ADDENDUM NUMBER 1

DATE:	Monday November 18, 2024
PROJECT:	170 Moeller Street Renovation
PROJECT NUMBER:	DELTA 2022.311.003
OWNER:	Broome County Land Bank Corporation
CONSULTANT:	DELTA ENGINEERS, ARCHITECTS, & SURVEYORS
TO:	Prospective Bidders

WEST ELEVATION- REMOVALS

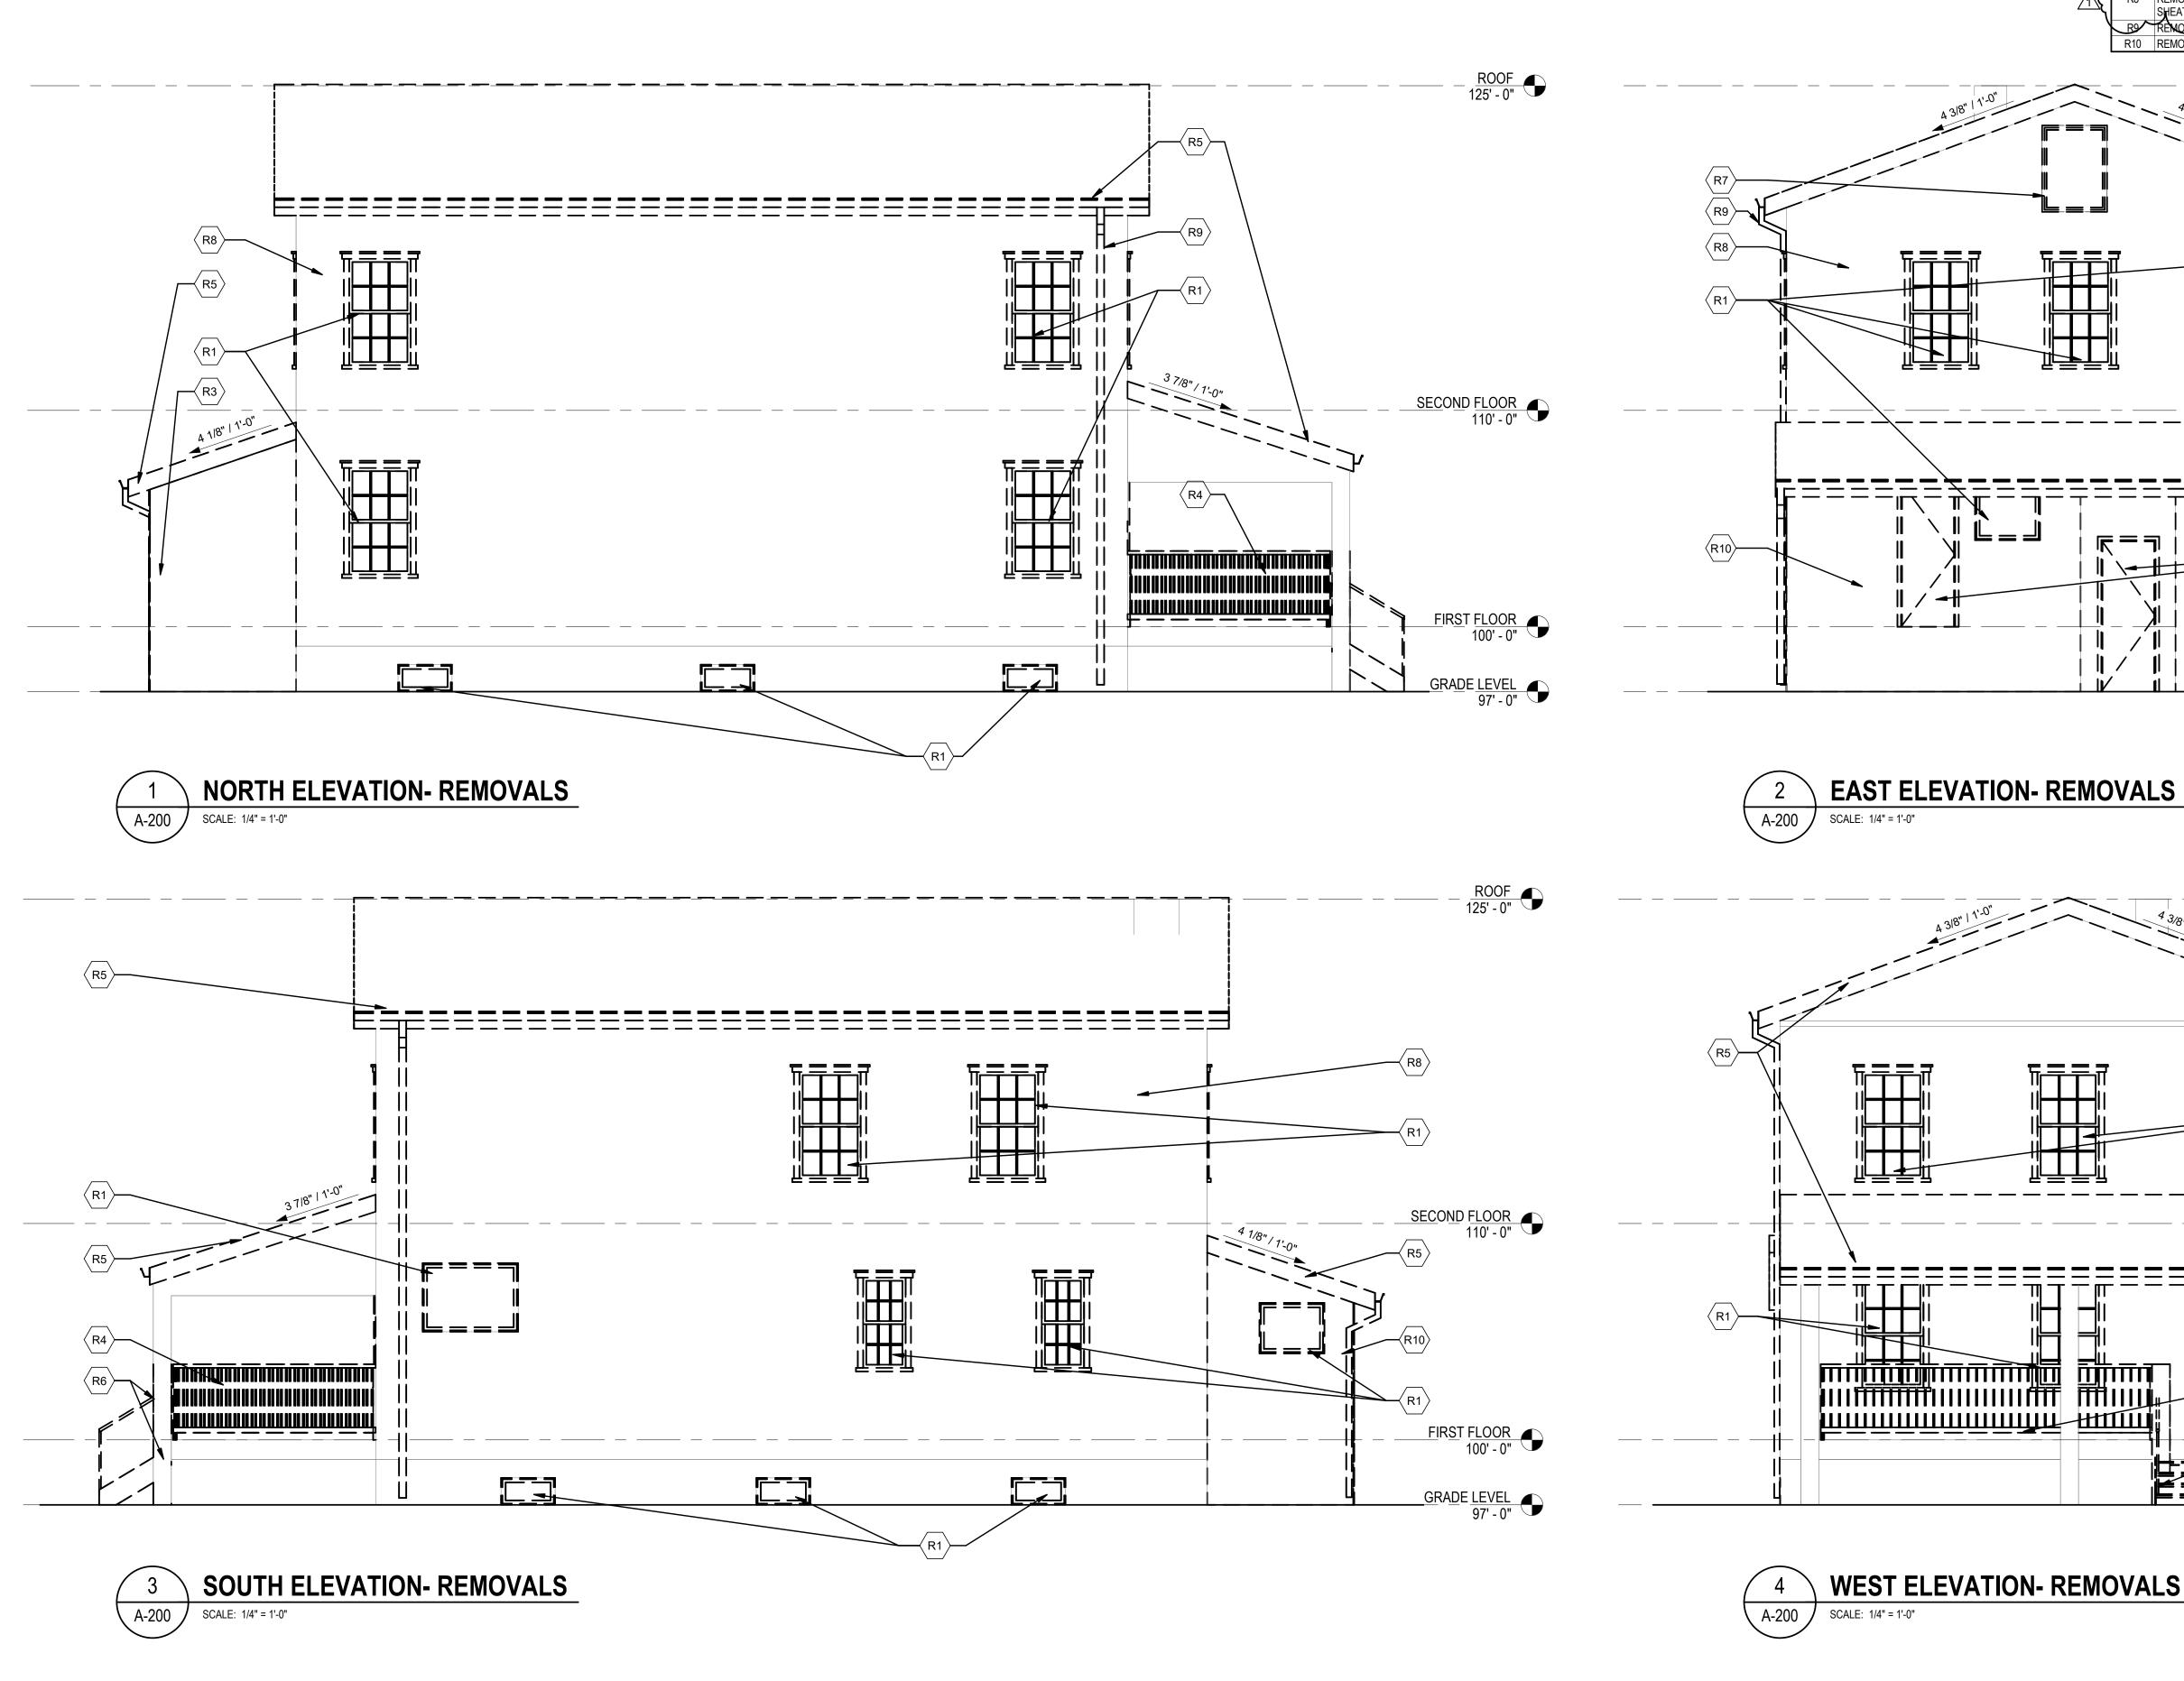
5. Outside sheeting has water damage on some big areas, please advise.

7. Stair raisers and treads are in bad shape some of then are rotten and damaged.

Response: See Addendum 1 revised sheet A-200 to clarify the removal of damaged existing sheathing.

Response: See Addendum 1 revised sheet A-200 to clarify the removal of damaged existing sheathing.

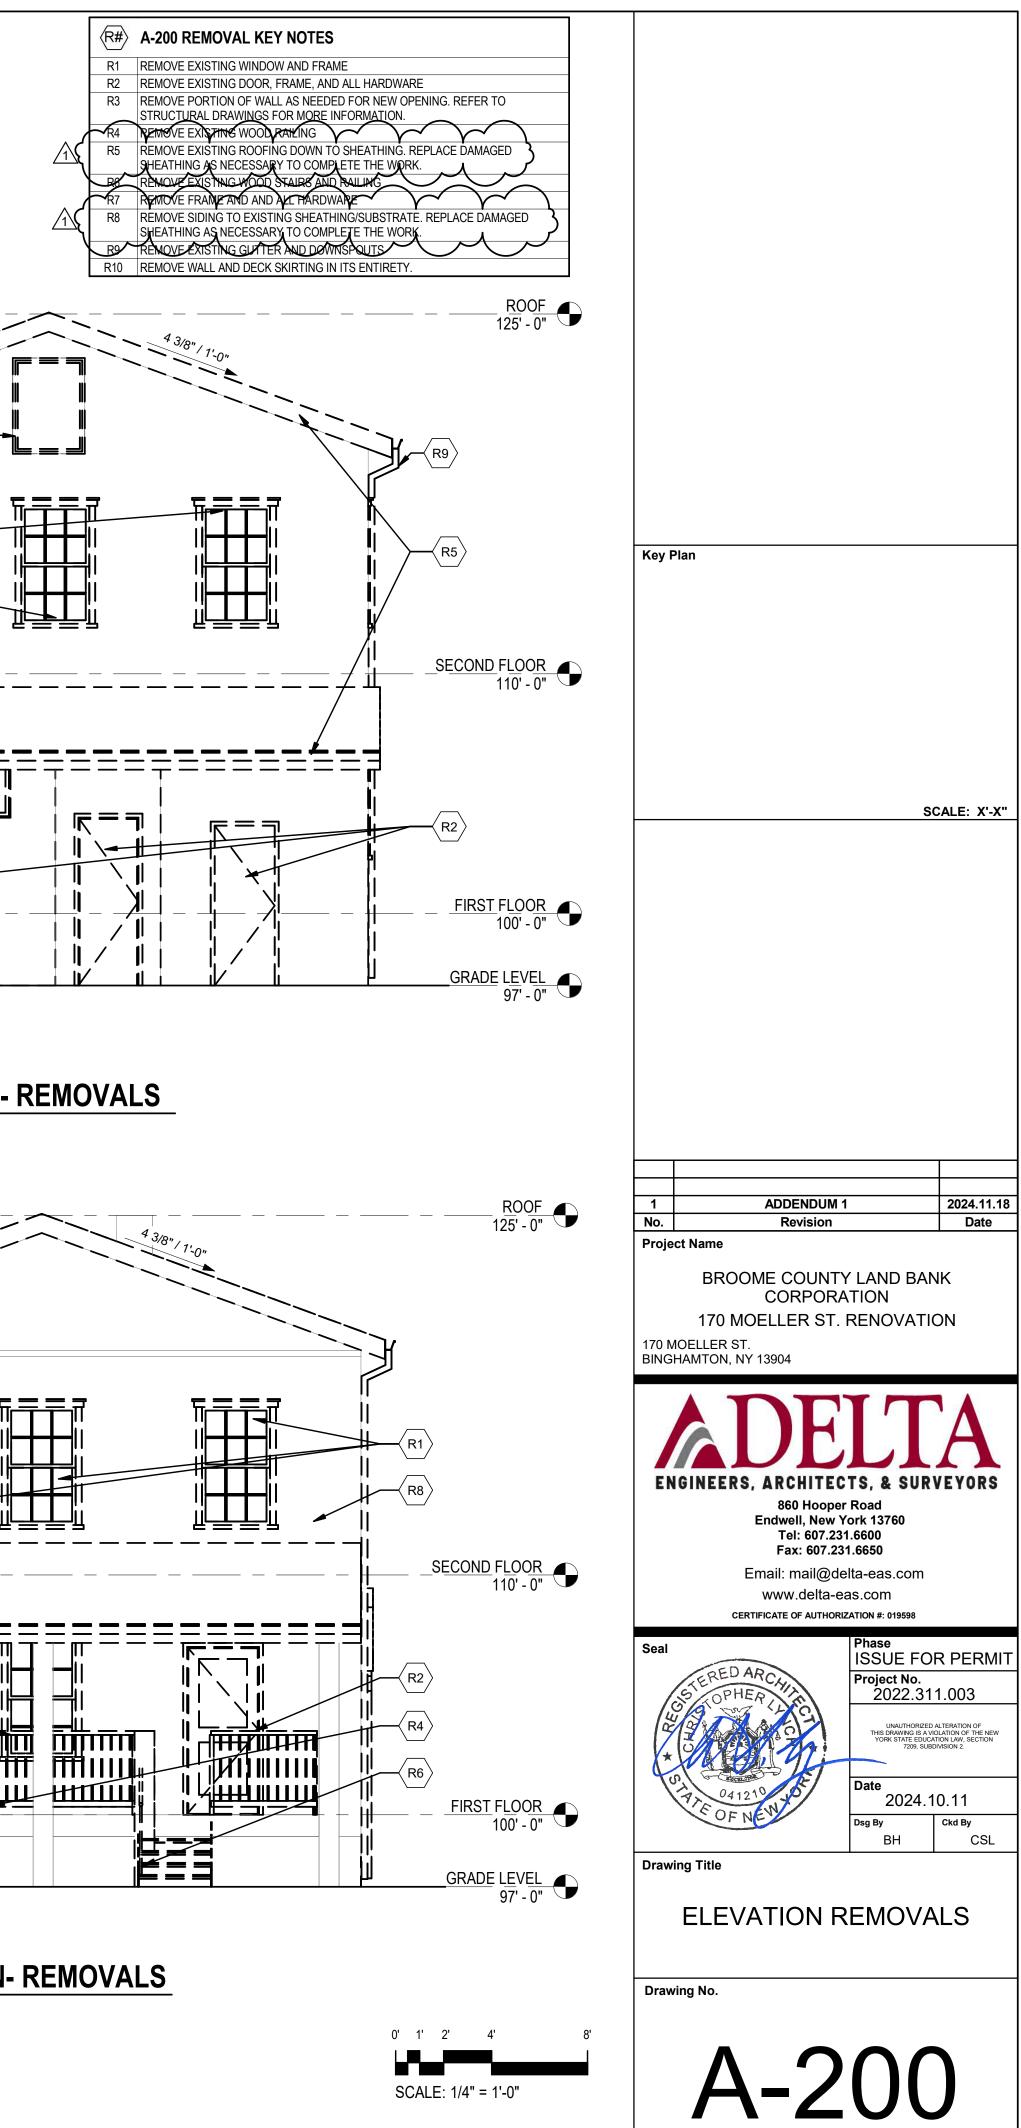
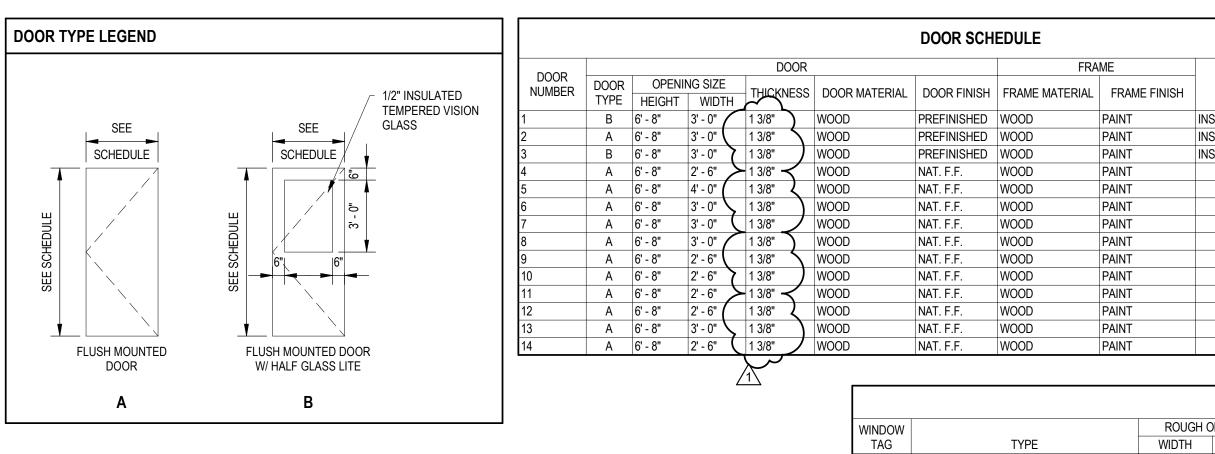
11. If 2" foam board is to be installed, window openings will need to be "built out" to accommodate new windows. Will any further detail be provided regarding build out framing?

12. Door schedule appears to call for 1 3/4" thick doors. Standard residential doors are 1 3/8" thick and hollow core. Can 1 3/8" thick hollow core doors be used as an alternative for interior doors?

Response: Windows and doors are to be installed in a manner to accommodate the insulated sheathing panel thickness. Jamb extensions are to be provided at the interior. See Addendum 1 revised window schedule on A-601.

Response: Yes, 1 3/8" residential doors are to be used. See Addendum 1 revised door schedule on A-601.
